Response to submissions and outstanding information – Moorebank Precinct West Concept MOD 1 (SSD 5066 MOD 1) / Moorebank Precinct West Stage 2 (SSD 7709)

# Moorebank Precinct West (MPW) Stage 2 (SSD 7709) Response to Submissions

# ATTACHMENT A – RESPONSE TO ISSUES RAISED IN NSW DP&E SUBMISSION

Figure 1 Single area source regions used in the construction noise impact assessment

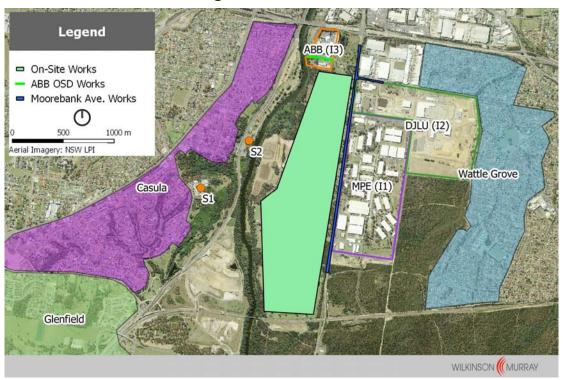
Aspect	Comment	Response	Reference
Noise Issues			
Ambient noise monitoring	Provide ambient noise monitoring data charts and/or raw electronic data from locations L1 to L3 as referenced from the MPW Concept Plan EIS (precise reference not provided and seemingly no longer available online);	Ambient noise monitoring data, in the form of noise logger plots were included in Appendix B of <i>Technical Paper 2: Noise and Vibration Impact Assessment</i> (SLR Consulting, 2014); prepared to support the Moorebank Intermodal Terminal Concept EIS. (https://majorprojects.affinitylive.com/public/246a966ba837c880137b190133a c9dd7/050%20Technical%20Paper%202_%20Noise%20and%20vibration%20(Part%20B).pdf).	Appendix B of the MPW Concept Approval EIS.
Construction site plan	Provide separate site plan showing each of the seven construction stages' equipment placements used in the model, relative to surrounding land-uses;	As discussed in Section 8.4 of the EIS, a total sound power level (SWL) was developed for each works period that was representative of all plant in the period operating simultaneously. Each SWL was then modelled as a single area source based on the footprint of the work period. These source regions are provided in Appendix D of the MPW Stage 2 RtS.  For the works period involving Moorebank Avenue, the total SWL of all plant as a single area source was modelled over the region shown on the figure. Since that works period also involved the internal roads on the MPW site, activities on the MPW site were also modelled, and then the highest predicted noise levels for each catchment was presented.  For the additional covered drain within the Endeavour Energy easement, as identified for the Amended Proposal, plant items were modelled as a line source, as shown in the figure provided at Appendix D of the MPW Stage 2 RtS.	Section 8.4 of the EIS. Appendix D of the MPW Stage 2 RtS

Figure 1 Noise Monitoring Locations

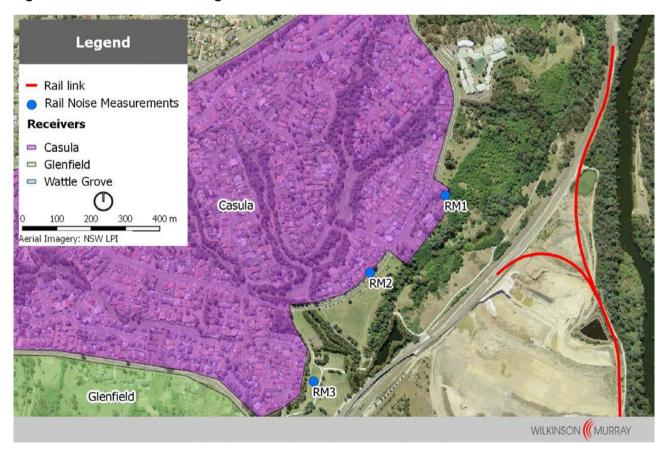
Rail track curvature	Confirm rail track curvature radii between the site and SSFL connection (eg provide a 2-D alignment map to scale or in digital format that can be used to measure radii);	An assessment of the impacts from the operation of the Rail Link connection to the Southern Sydney Freight Line is included in the MPE Stage 1 Approval (SSD 14-6766) and is outside the scope of this Proposal. The Proposal seeks approval to operate on, and not for the construction of, the Rail link.	MPE Stage 1 EIS (SSD 14- 6766)
Existing rail noise	Section 8.2.2 implies that existing rail traffic noise is significant and that the additional movements are not significant in terms of volumes when compared to existing. An analysis of existing rail noise levels at the three residential areas should be provided and the expected change in rail noise due to the Proposal demonstrated to "unlikely to noticeably increase due to the Proposal". For example, the reference to 77 Leacocks Lane and Lot 21 Leacocks Lane noise levels is unclear (stated as 3 to 5 dB increase because of the relative shielding to the track for these two locations). It is unclear if this issue is limited to this location or a small number or properties or if this issue extends across many properties;	An assessment of rail noise from the Proposal has been included in Section 8 and Appendix N of the EIS. A projected rail noise impact assessment has been undertaken and is included at Appendix D of the MPW Stage 2 RtS. Based on the corrected measurements as included in the Noise Technical Memorandum, provided at Attachment B of this memorandum, the predicted Laeq,period rail noise levels at nearby noise sensitive as a result of the Proposal comply with the RING criteria for private non-network rail lines at all receivers, except Casula. Therefore, a more detailed assessment of Laeq rail noise levels in Casula was considered warranted, and requires that the existing levels of rail noise be established at this location only.  Rail noise modelling indicates that the Laeq,period rail noise levels from the Proposal would comply with the RING criteria for "private non-network rail lines" in Wattle Grove and Glenfield, but would exceed the night time criterion by up to 4 dB in Casula. These criteria are considered particularly stringent to the extent that the existing Laeq and Lamax noise levels are already above the criteria. Laeq and Lamax rail noise levels at the most sensitive residential receivers near the Rail link are predicted to exceed the established noise goals. However, due to the proximity of these receivers to the Southern	Section 8 and Appendix N of the EIS. Appendix D of the MPW Stage 2 RtS.

Aspect	Comment	Response	Reference
		Sydney Freight Line, rail movements associated with the Proposal are not expected to result in a noticeable change to the existing L <sub>Aeq</sub> and L <sub>Amax</sub> rail noise levels.	
		Further rail noise monitoring has been undertaken in February 2017 to greater establish existing rail noise levels at Casula, which would be representative of noise levels at 77 Leacocks Lane and Lot 21 Leacocks Lane. Existing levels of rail noise have been established at a number of locations in Casula, including the area where the <i>Rail Infrastructure Noise Guideline</i> (RING) criterion is predicted to be exceeded. At the rail noise monitoring locations, it is demonstrated that the Proposal would result in an increase in the night time LAeq,period rail noise level of less than 2 dB, which is considered unlikely to be noticeable and does not warrant mitigation. It should be noted that the existing rail noise levels are greater than the contribution from the Proposal.  The existing rail noise levels that have been established as part of the additional monitoring are representative of a number of properties near the Proposal, including 77 Leacocks Lane and Lot 21 Leacocks Lane, Casula.
